**RE: IVANHOE ESTATE STAGE 1 DEVELOPMENT APPLICATION
STORMWATER AND DRAINAGE ASSESSMENT ADDENDUM – BUILDING C1**

Throughout the detailed design process a number of changes have been made to the C1 site and Aspire are aiming to lodge a Section 4.55 modification to amend the current consent. This letter has been prepared to outline the impact of the changes on the stormwater controls proposed under the approved report and to outline the changes required to maintain compliance with Ryde Council's Standards. This letter should be read in conjunction with the approved report.

drawing title:
**STAGE 1
CATCHMENT PLAN**

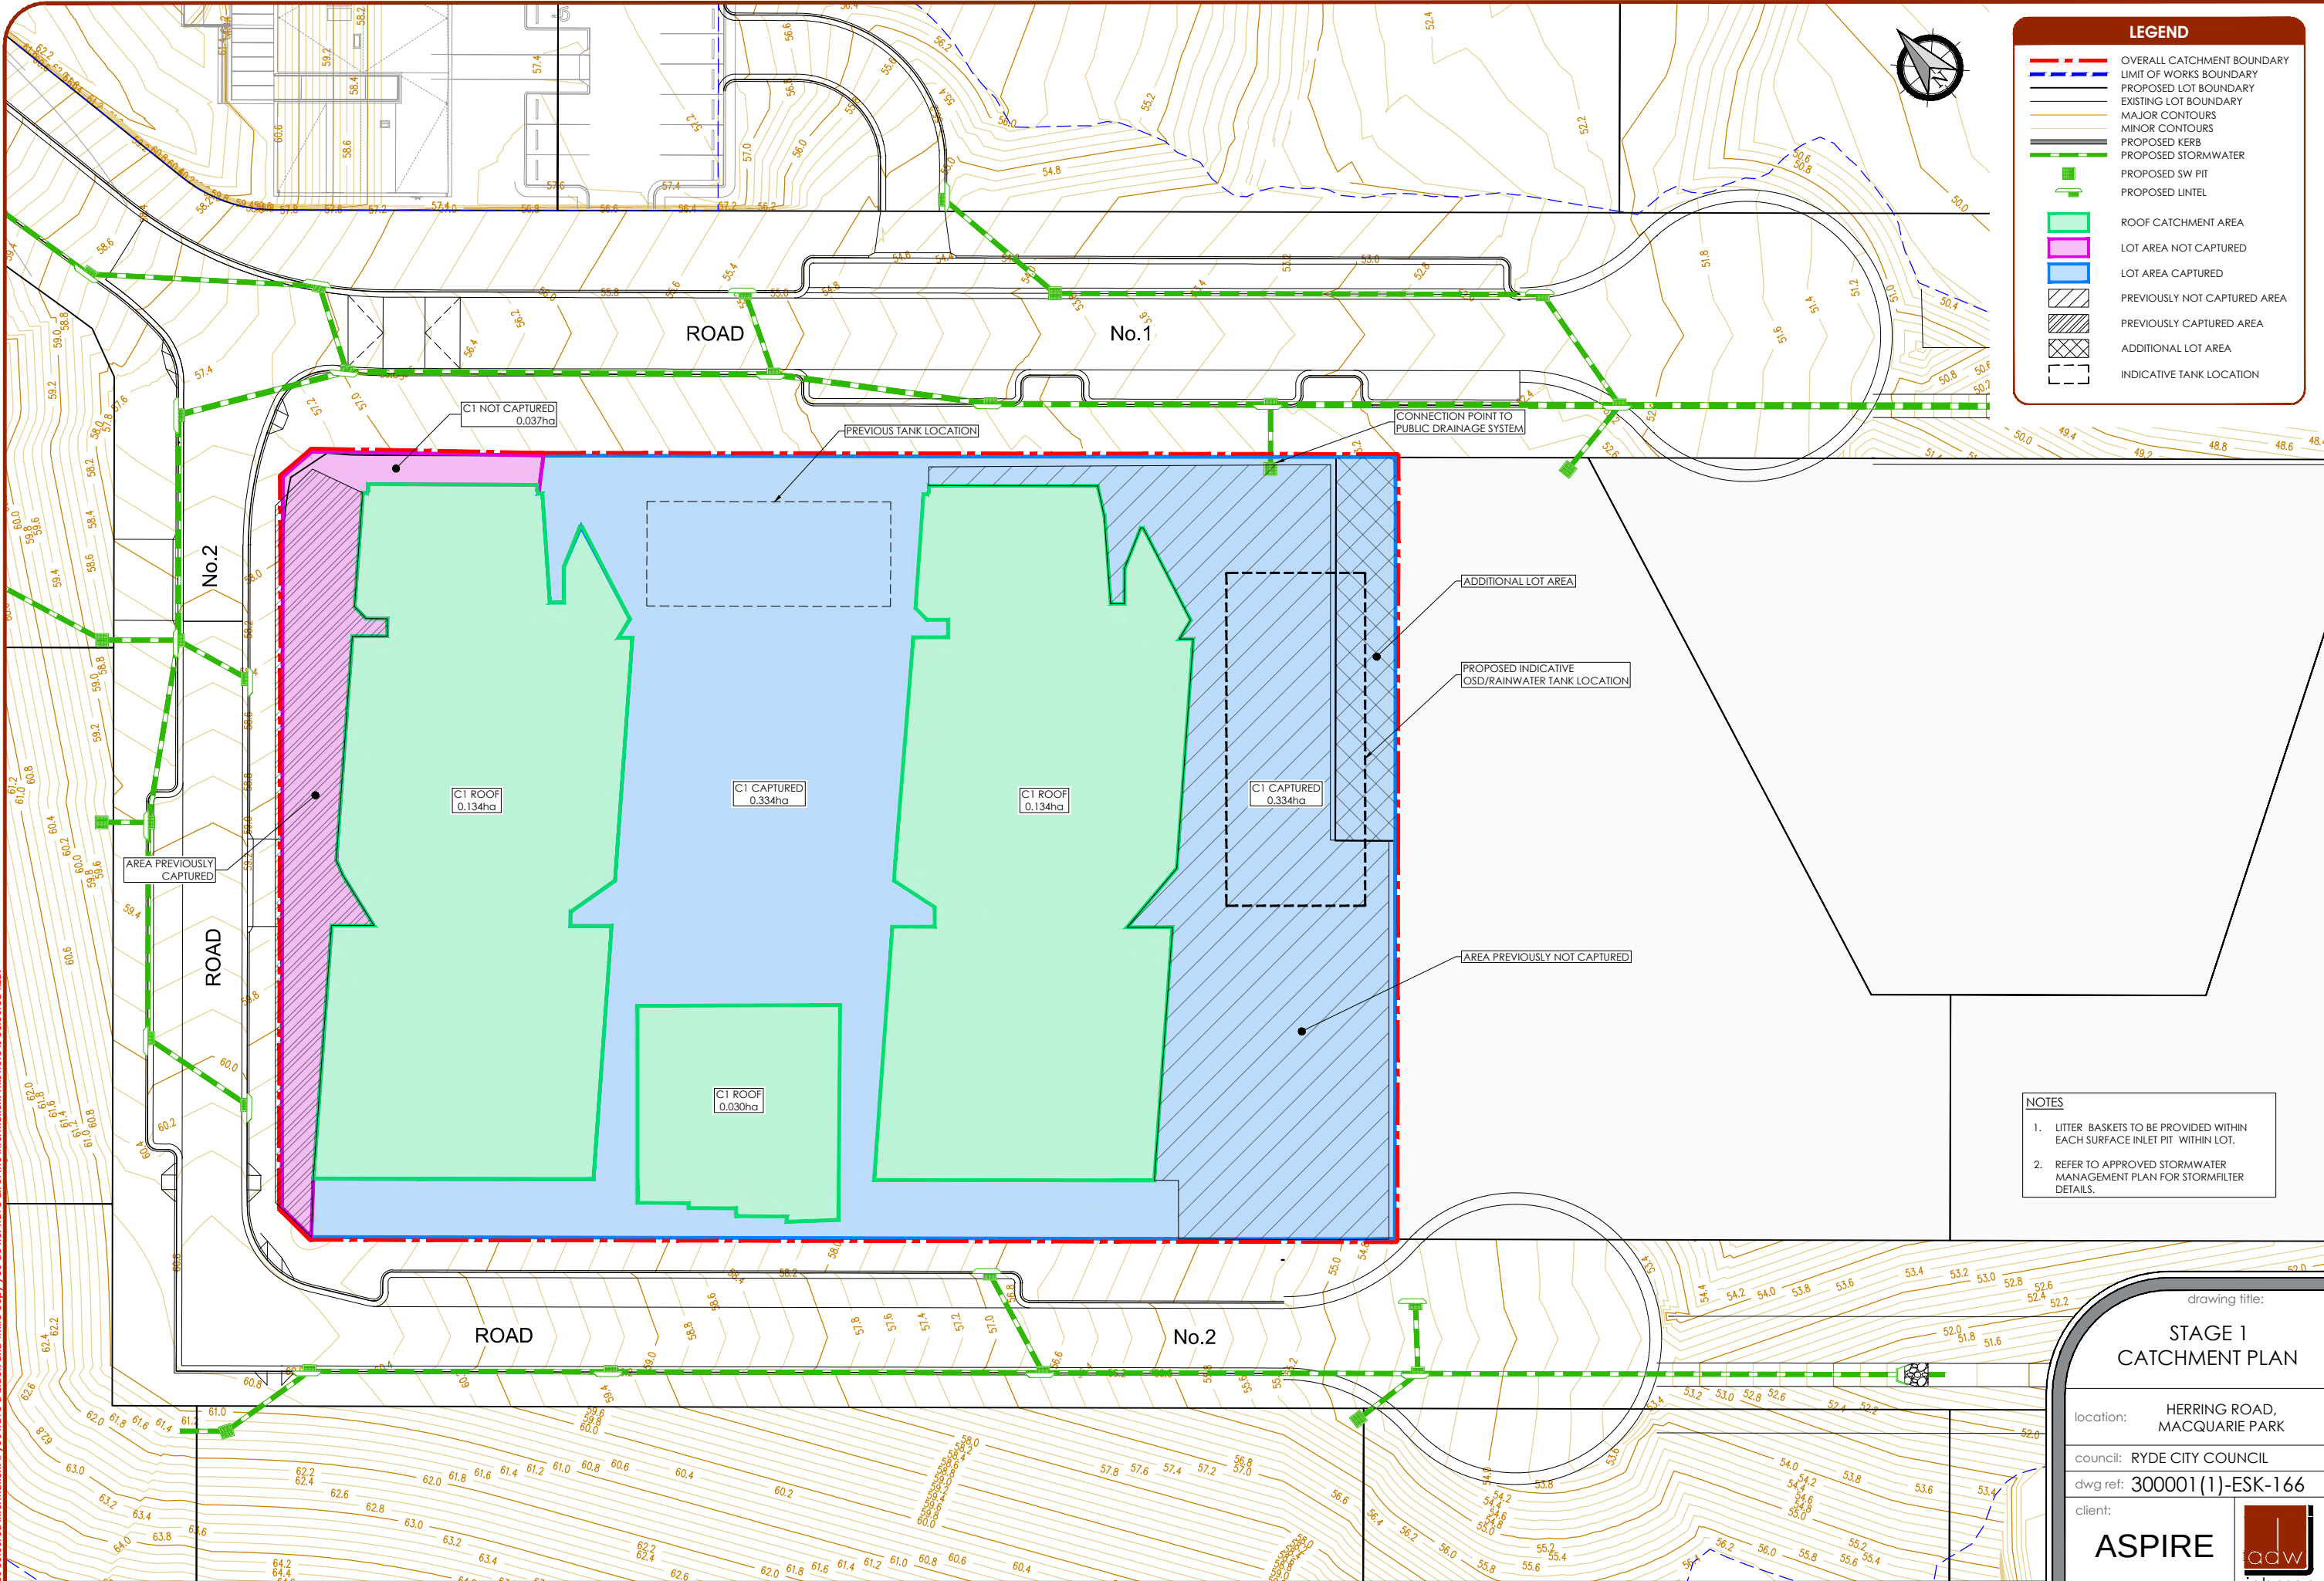
In accordance with the approved report, to ensure the runoff generated by the C1 site is accurately calculated the lot has been split into three (3) sub catchments being roof, remaining lot captured and remaining lot not captured.

The sub catchment areas can be seen in **Appendix C** and **Table 1** below.

Catchment	CATCHMENT AREA (ha)		
	Roof	Remaining Lot (Captured)	Remaining Lot (Not Captured)
C1 - Original	0.298	0.224	0.113
C1 - Updated	0.298	0.334	0.037

As mentioned in section 2.0 the location of the tanks have been amended from the approved report to a location that allows additional runoff to be captured.

It can be seen from **Table 2** that the proposed changes to the C1 site have resulted in the required tank size increasing by 15 m³. The updated tank parameters can be seen in **Table 3** below.

Detention Tank	Volume (m ³)	Tank Depth (Excluding Emergency Weir*) (m)	Low Flow Orifice (mm)	Weir Length x Height (m)
C1 – Original	100	1.5	225	2m x 0.2m
C1 - Updated	115	1.5	290	2m x 0.2m

From **Table 5** above it can be seen that the proposed changes to the C1 site has resulted in a smaller water quality system being required to meet Council's water quality targets. The reduction in the system size can be explained by the modified location of the proposed tank which has now allowed more water to be captured, and therefore treated, than the previous design.

It should be noted that, in addition to the Stormfilter parameters outlined above, litter baskets should be provided within any surface inlet pit within the site.
